TECHNICAL EVALUATION REPORT

TENDON EVALUATION

ROCHESTER GAS AND ELECTRIC COMPANY
R. E. GINNA NUCLEAR POWER STATION

Review of Rock Anchor Evaluation

FIGURE 4-1
FACTOR METHOD

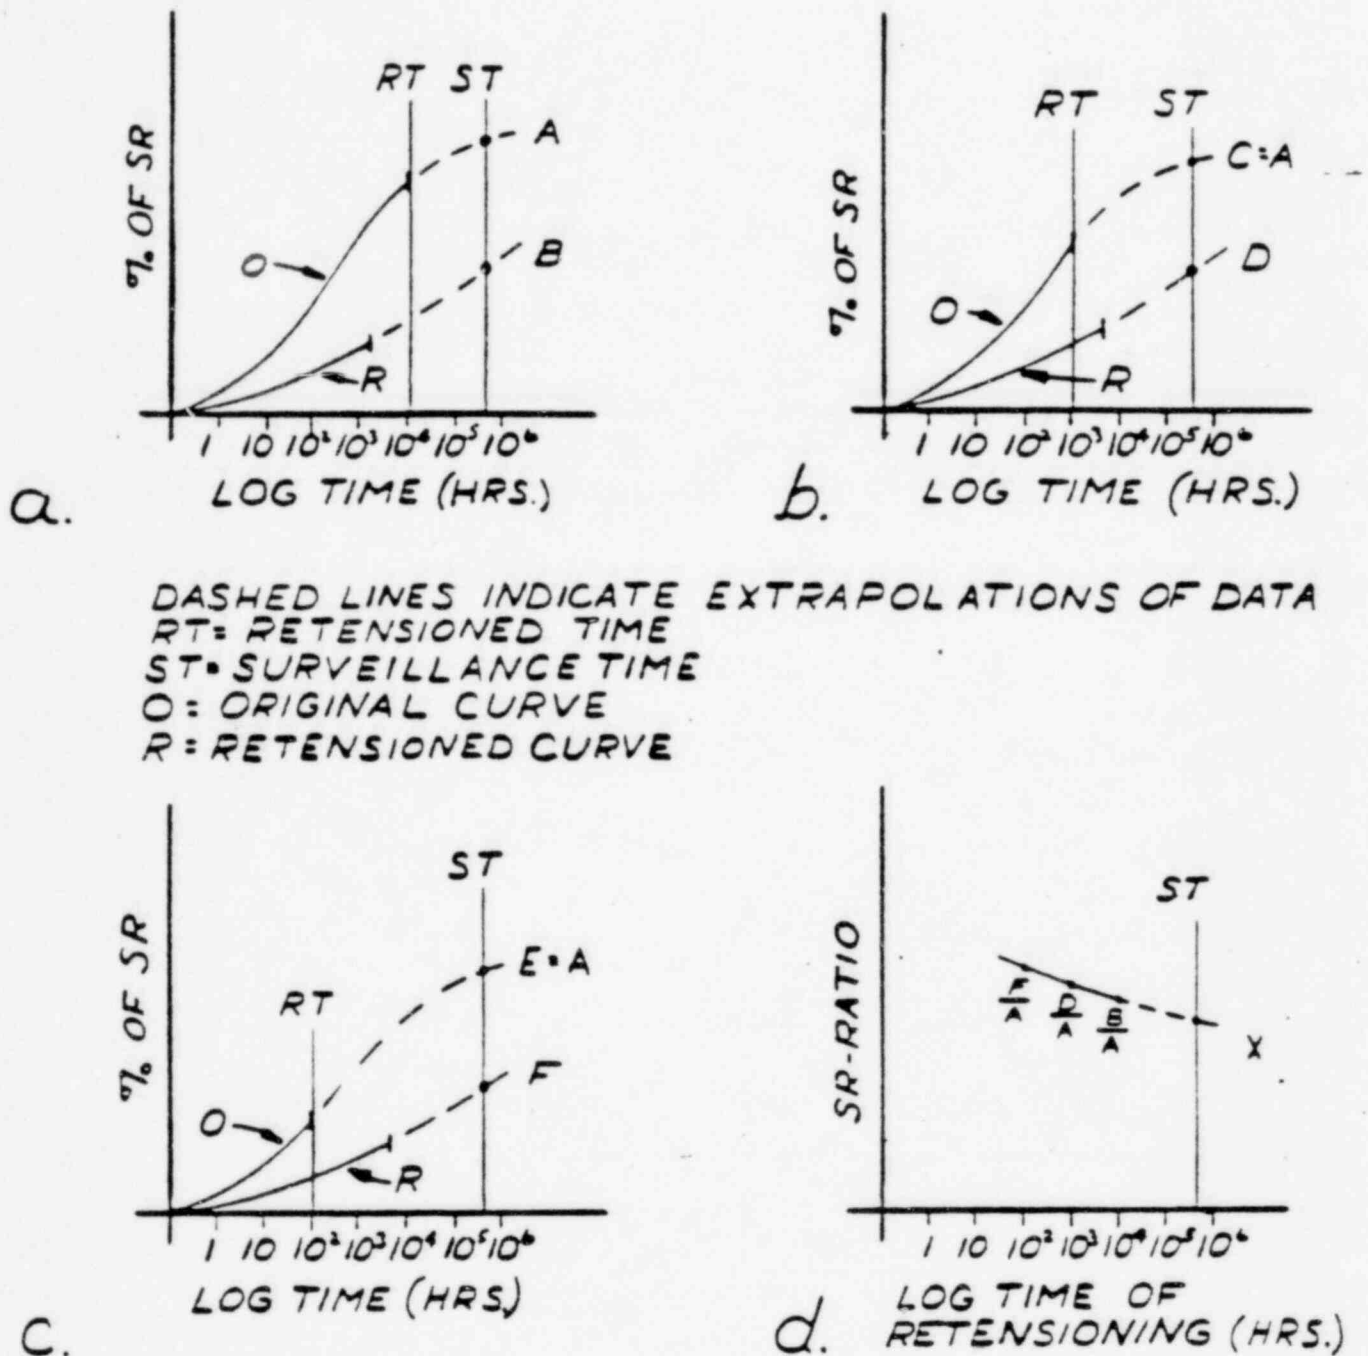
Review and evaluation of the factor method indicates that the method uses the relaxation data from empirical tests of retensioned tendon wires. However, very few data are available for use by this method.

The whole approach was based upon three test specimens from one tendon wire, in which each test specimen represented one decade of time at the initial load. Consequently, while the method represents a good approach, confidence in the method must come from its application in continued tendon surveillance.

IDEALIZED DISTRIBUTION OF
GROUT/ROCK BOND STRESSES

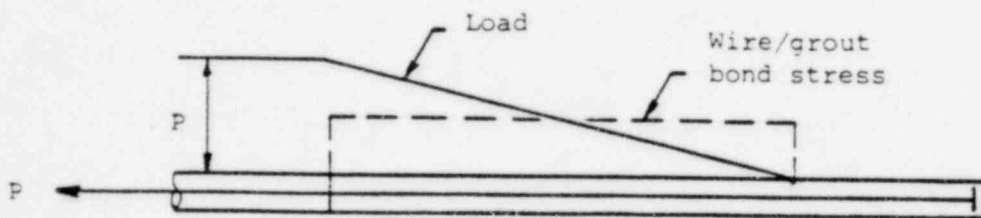
Figure 3, reproduced from Gilbert Associates' February 1982 report, shows idealized distributions of the grout/rock bond stresses during stressing of the rock anchors and subsequent stressing of the wall tendons. The average bond stress in the first-stage grout at the maximum anchor test load ($0.8 f_u$) was 163 psi, assuming that the load was distributed over the entire length of the first-stage grout. A conservative estimate of the load in the second-stage grout during testing of the wall tendons to $0.8 f_u$ was obtained by assuming that the load in the anchor had decreased to $0.6 f_u$ prior to stressing of the wall tendons. This results in a load of 212 kips ($0.2 f_u$) in the second-stage grout and an average bond stress of approximately 100 psi, assuming that the load is distributed over the entire length of the second-stage grout. The average bond stress of 340 psi at which slip occurred in the small-scale anchor tests is about twice the maximum average bond stress of 163 psi in the first-stage grout and more than three times the maximum average bond stress of 100 psi estimated for the second-stage grout. Based on this comparison, Gilbert Associates conclude that the bond stresses in the full-scale anchors were not large enough to produce slip at the grout/rock interface.

MEASURED VS CALCULATED
TENDON ELONGATIONS
ORIGINAL TENSIONING

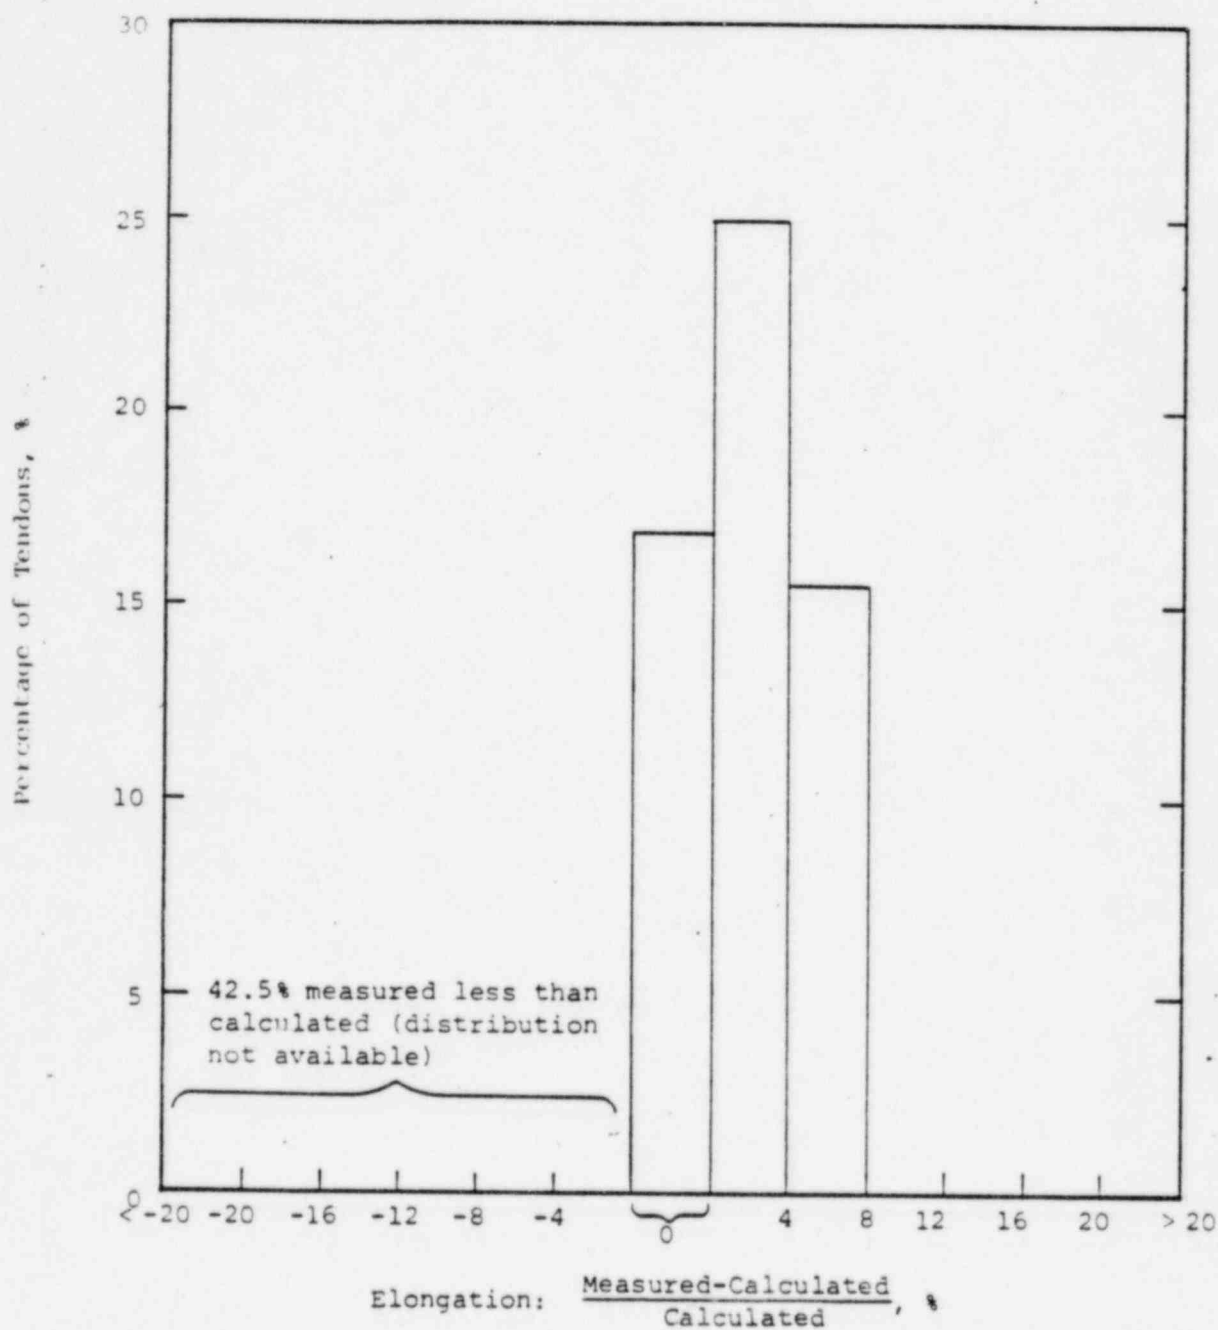
The tendon elongation data presented in the reports by Gilbert Associates are plotted in histogram form in Figs. 5 and 6. The histograms show the distribution of the differences between the measured and calculated tendon elongations for the original tensioning and the June 1980 retensioning. For the original tensioning of the wall tendons (Fig. 5), the distribution of the measured elongations that were less than the calculated elongation are not shown because this information was not available in the documents provided to us for our review. For the June 1980 retensioning (Fig. 6), the data for straight tendons and curved tendons is separated because excessive friction in the curved tendons could obscure the comparison between the measured and calculated elongations. The information available to us on the original tensioning (Fig. 5) did not permit a similar separation of the data for straight and curved tendons.

Franklin Research Center Philadelphia, Pennsylvania	Rock Anchor Review Ginna Nuclear Plant	CREEP EXPONENT VS STRESS LEVEL
 GEOTECHNICAL ENGINEERS INC. WINCHESTER • MASSACHUSETTS	Project 84460	January 10, 1985 Fig. 7

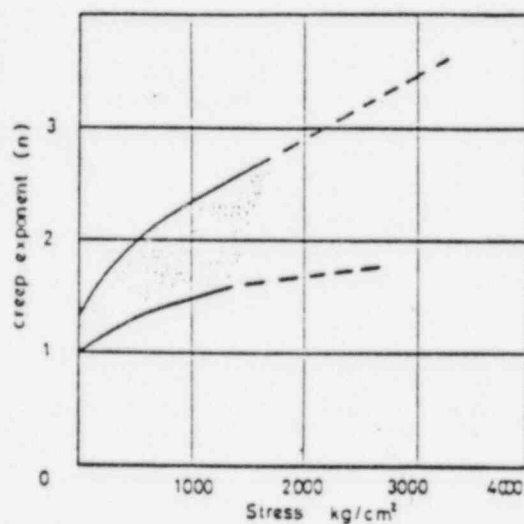
The creep analysis presented by Gilbert Associates is not correct because the empirical creep exponent is stress-dependent, as discussed in Ref. 1. Figure 7, reproduced from Ref. 1, shows an empirical relationship between the creep exponent and stress level. This figure indicates a range of $n = 1.1$ to 1.4 for the creep exponent at a stress level of 472 psi. Using this range of values in Gilbert Associates's analysis yields a predicted load loss in the range of 8 to 122 kips.
